# Rezoning Transportation Analysis

Petition Number: 2018-049

**Revision Log:**

Date	Description
05-24-18	First Review
06-14-18	Second Review

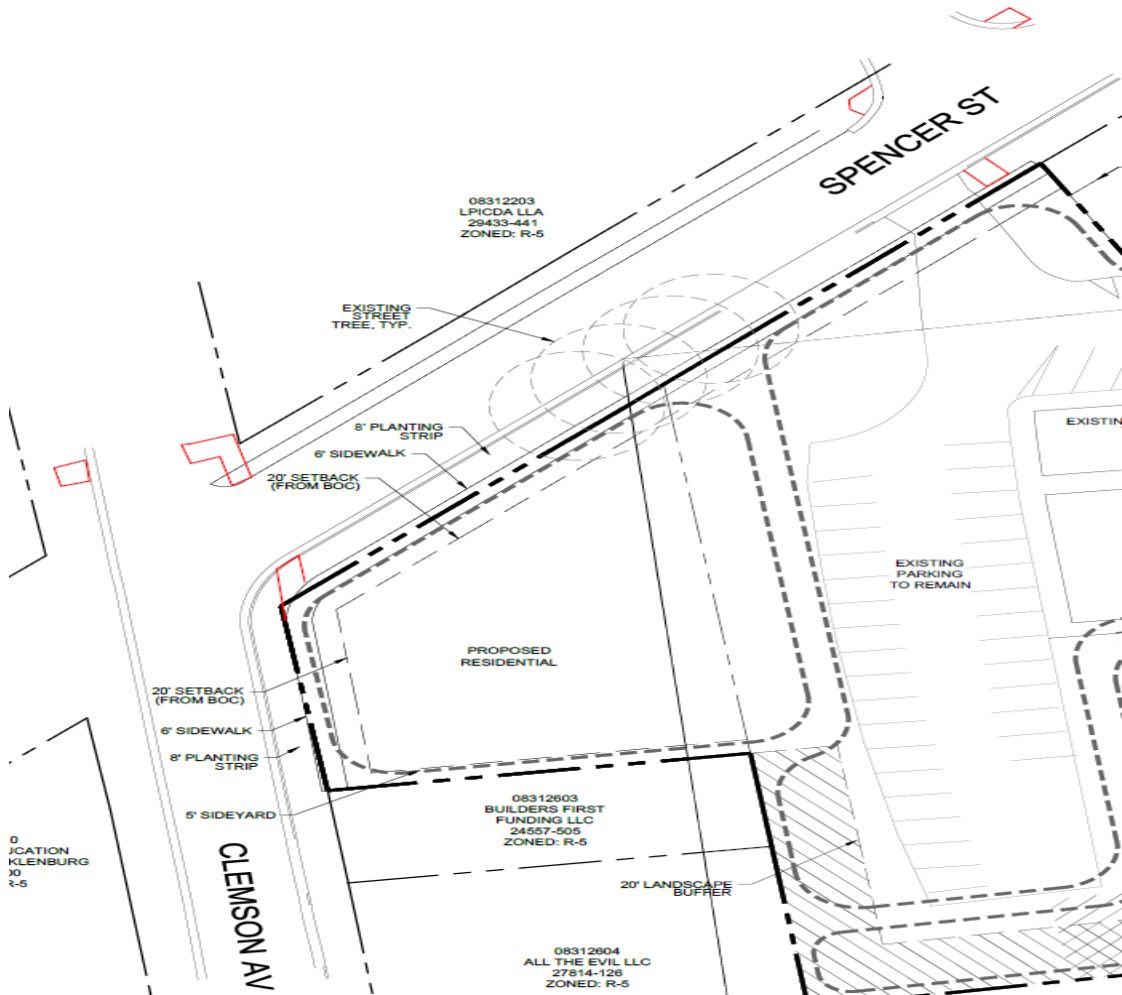
- ~~**Curbline** The proposed zoning district has a setback measured from back of the existing or proposed future curblines. The existing back of curbs are in the correct future location for Charles Avenue, Clemson Avenue, Spencer Street and Whiting Avenue.~~
- ~~**Traffic Study** A Traffic Impact Study/Transportation Technical Memorandum is not necessary for the complete review of this petition.~~
- The petitioner should revise the site plan and conditional note(s) to show the proposed sidewalk on Charles Avenue extending to the intersection with Clemson Avenue. This would provide pedestrian access from the proposed development to the Clemson Avenue Park.
- The petitioner should revise the site plan and conditional notes to show curb ramps at the intersection of Spencer Street and Clemson Avenue and the intersection of East 34<sup>th</sup> Street and Spencer Street as shown below:
